MAYOR AND COUNCIL OF THE TOWN OF WINDERMERE

January 24, 2023

Re: Third Town Council Workshop Windermere Downtown PUD Final Engineering Plan

WINDERMERE
DOWNTOWN
PROPERTY

L1.01

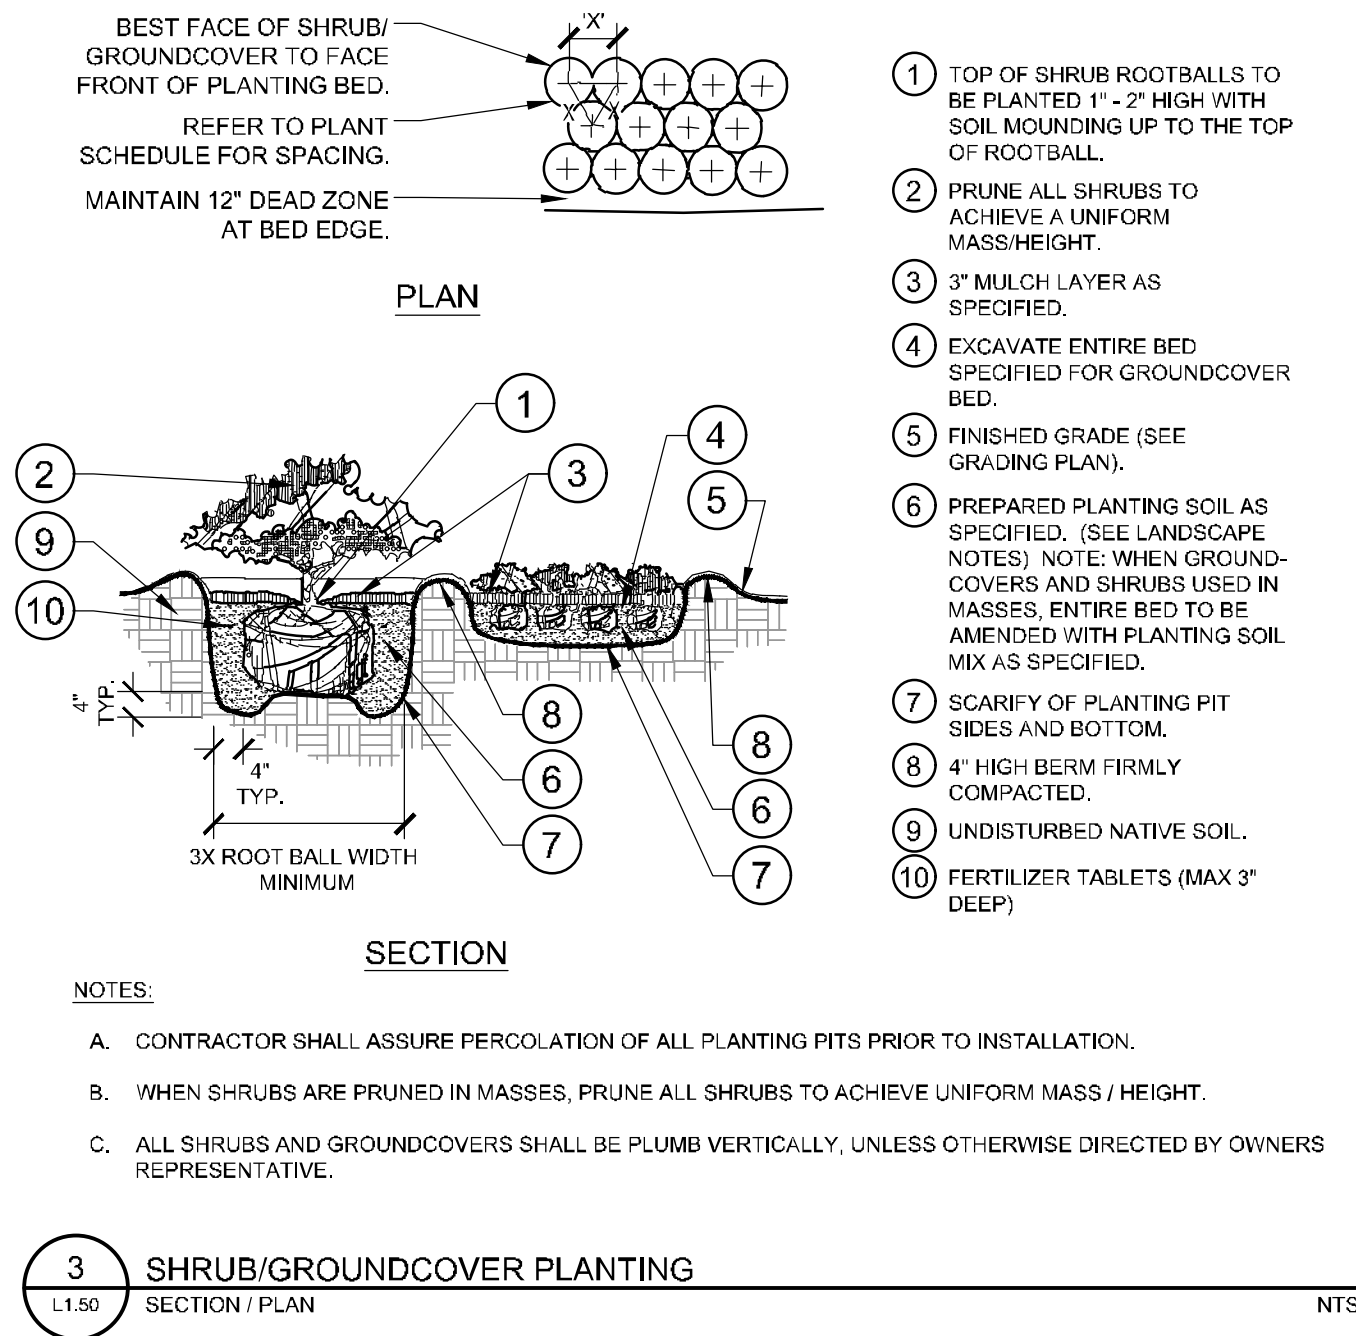
2. The proposed buffer wall between the parking lot and E 6th Avenue is shown as only 3 feet in height. The Town's Town Center Design District requires all buffer walls between the parking lot and ROW be 6 feet in height. I am aware there was discussion during the Tree Board reviews and site visit about reducing the height to 3 feet along E 6th Avenue. However, I have received comments from residents that live on Oakdale Street to the south of E 6th Avenue that the 3-foot wall will not appropriately shield headlights from the parking lot reaching their homes directly across E 6th Avenue. Because the Town Center Design District requires the 6-foot buffer wall height, I will have to make that comment during the next Town Council workshop.

TRUCK ROUTING EXHIBIT

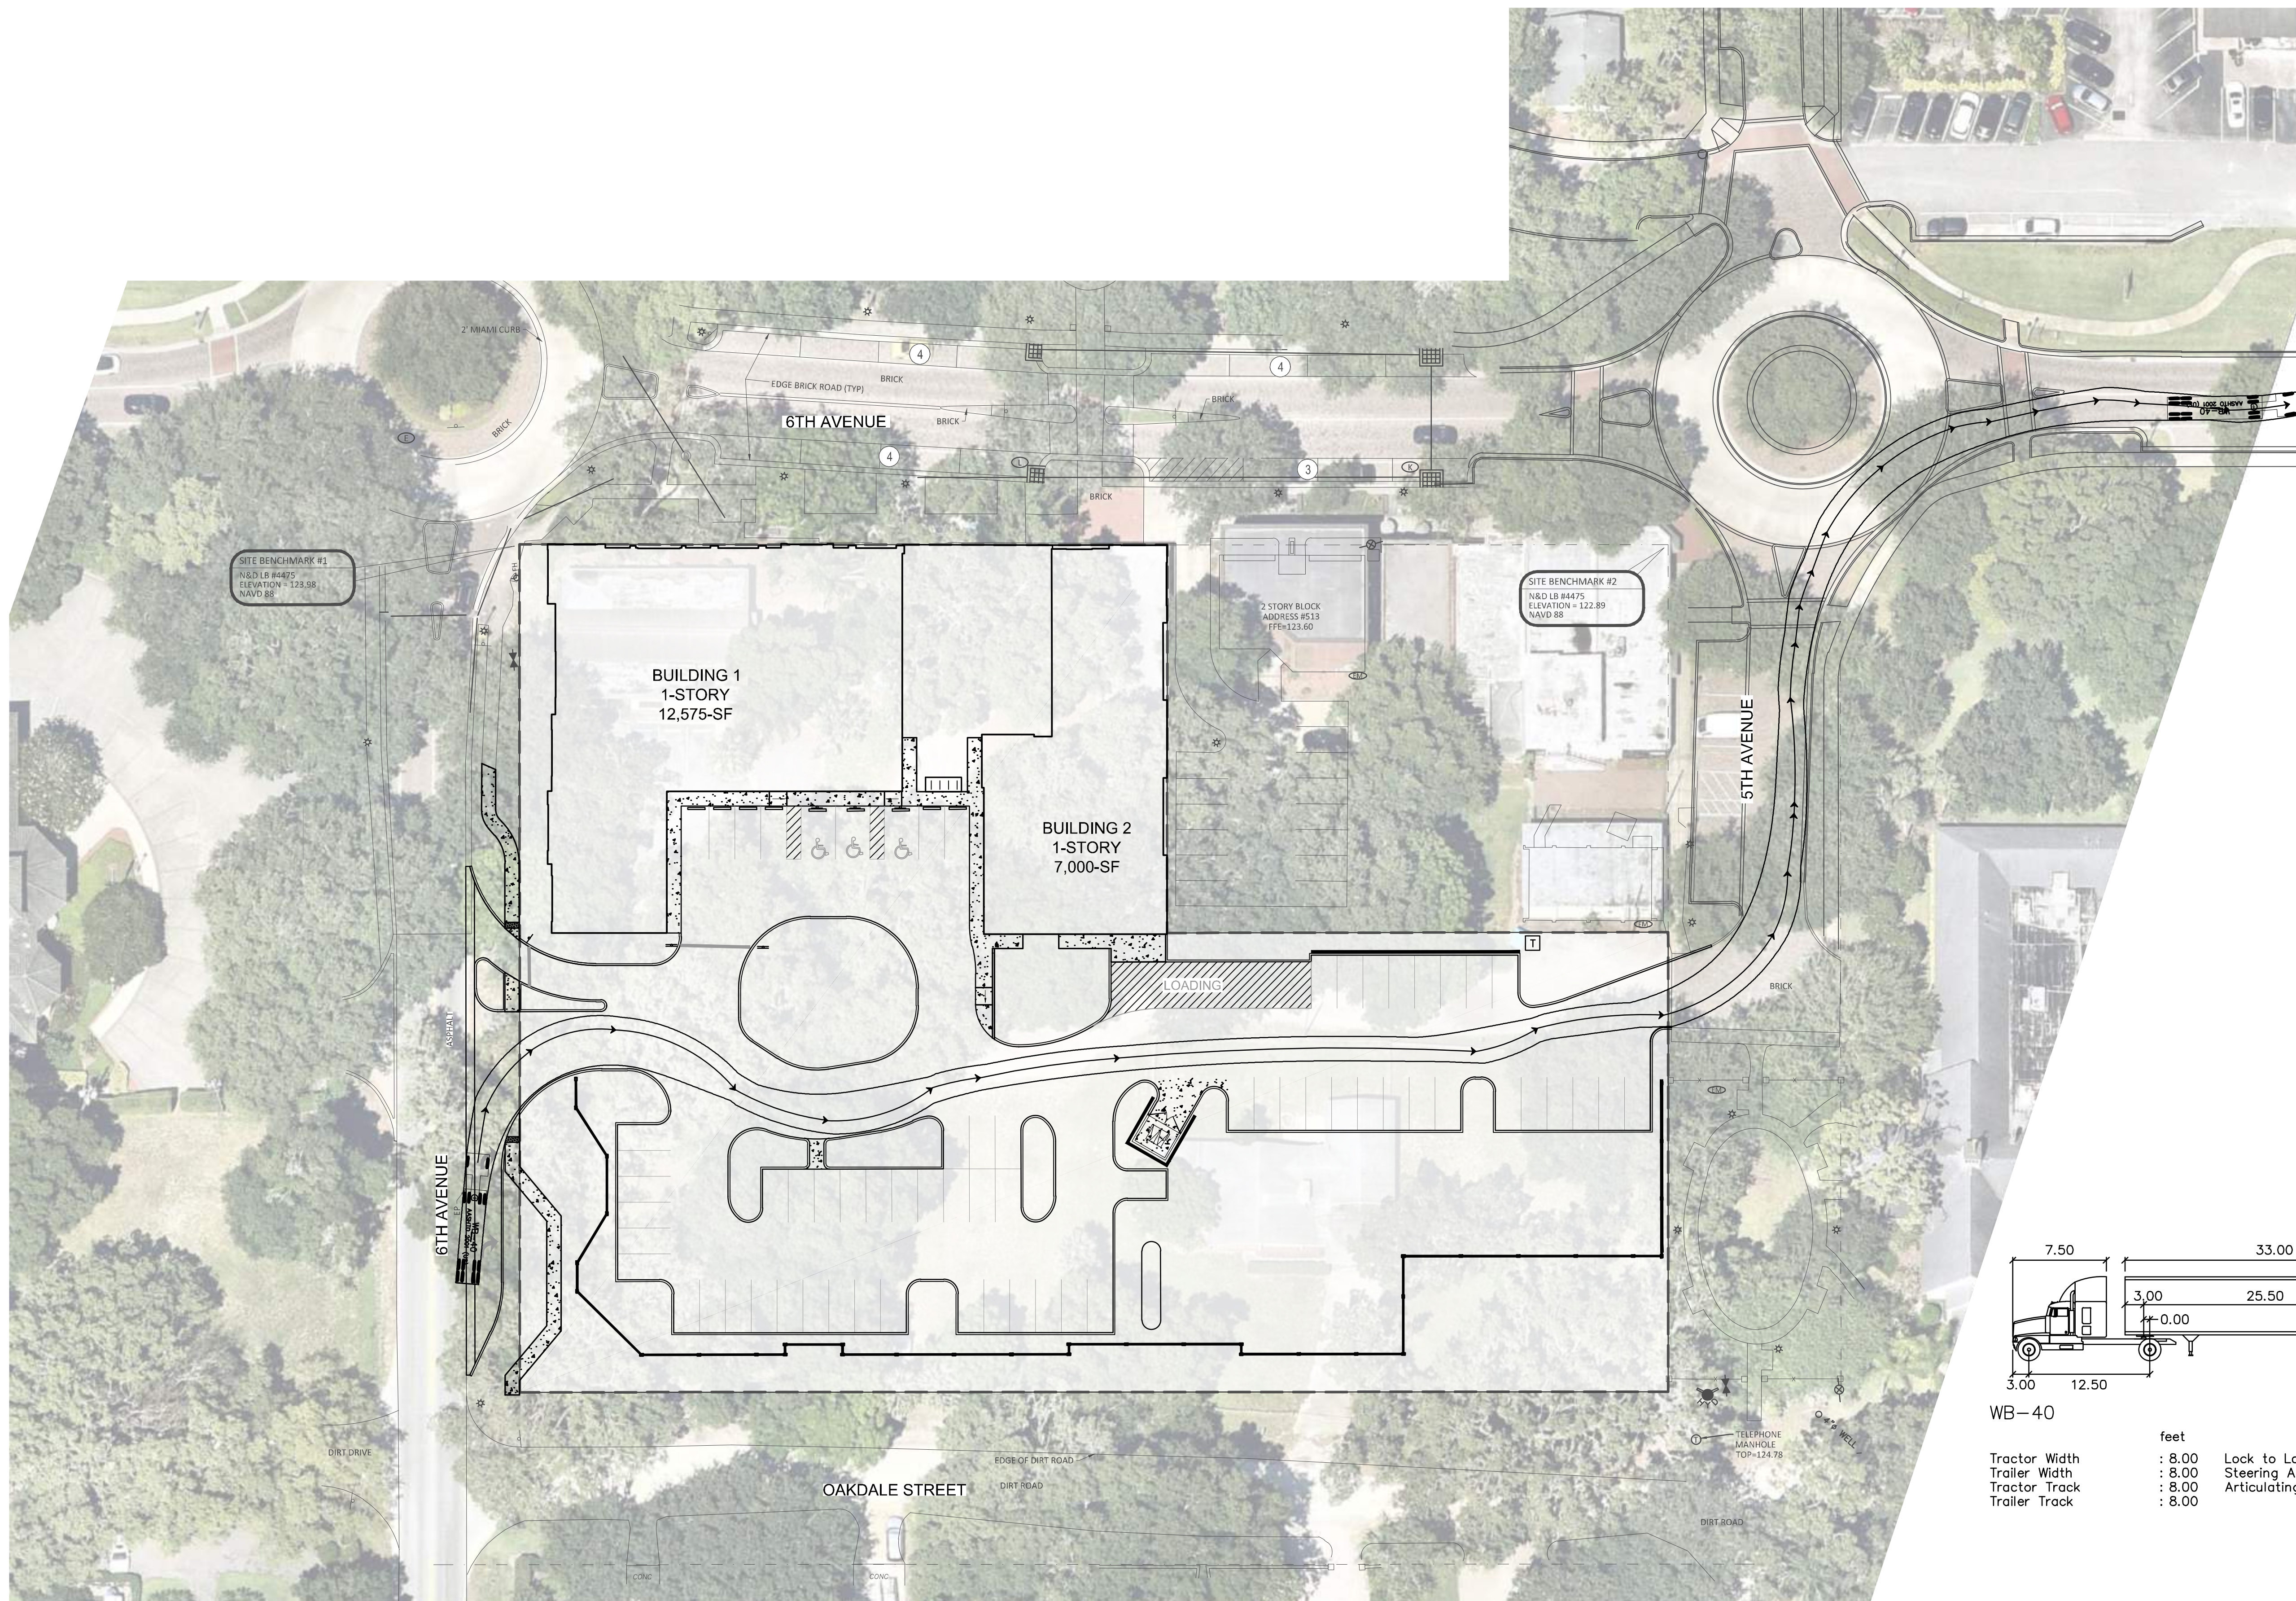
1. The review of the truck routing exhibit was coordinated with Town Public Works. The truck routing exhibit shows the pathing of the truck on E 5th Ave encroaching over or directly adjacent to the curbing on the north side of the ROW of E 5th Ave. In the truck routing exhibit link (image) below this comment, I added photos of the E 5th Ave ROW (taken on November 3, 2022) that shows that the pathing of trucks on the truck routing exhibit will most likely impact and damage the existing trees, may damage a storm drain inlet, and may significantly damage the curbing. In addition, as the photos show, there is legal on-street parking that may hinder the path of trucks exiting to E 5th Ave. The truck routing exhibit also shows that the truck can only go northbound out of the round-a-bout at E 5th Avenue and Main Street.

Have you (applicant) evaluated the E 5th Avenue road material to assure it is sufficient to accommodate the weight of the trucks, particularly related to the proposed hardware store use?

How will the potential negative impacts of the trucks exiting to E 5th Avenue and continuing to the round-a-bout be prevented or mitigated? How will you assure that truck traffic only heads northbound from the round-a-bout at E 5th Avenue and Main Street?
